**MINING AND RECLAMATION PLAN  
SUFACO MINE  
AMENDMENT**

**South Fork Quitcupah 2R2S Block "A"**  
**JULY 2012**  
Revised January 2013

Re: South Fork Quitcupah 2R2S Block "A" Amendment, 4<sup>th</sup> and Final Submittal, to the Canyon Fuel Company, LLC, Sufco Mine, Permit Number C/041/0002

Figure 7-9 Monitoring stations in the South Fork of Quitcupah Creek area.

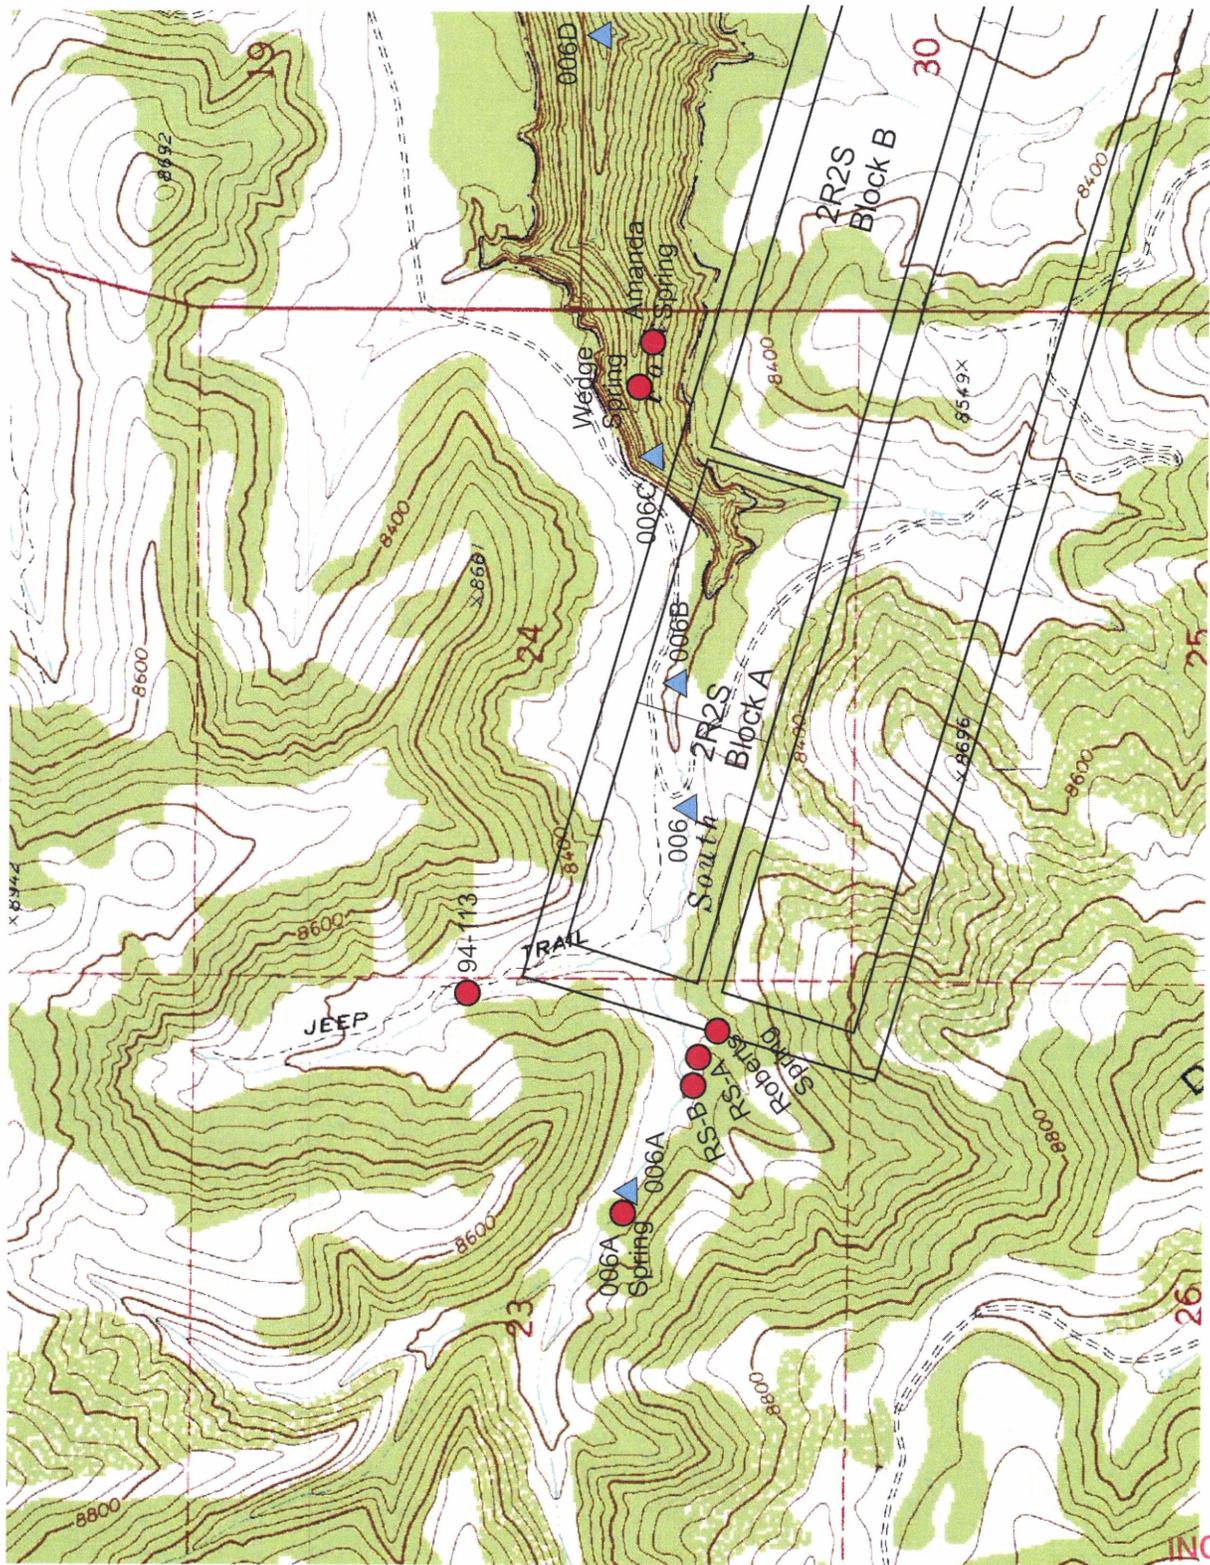
1. **R645-301.731.224:** The downstream surface water monitoring point 006D should be added to Figure 7-9 in the MRP and included in the gain/loss surveys to be completed as part of the mitigation plan. (AAA)

Item #1 was addressed by adding monitoring point 006D to Figure 7-9, page 7-51K in the MRP and in the new Mining and Mitigation Plan for Undermining the South Fork Quitcupah 2R2S Block "A". A gain/loss survey that includes 006D has been added to the MRP as Appendix 3-14.
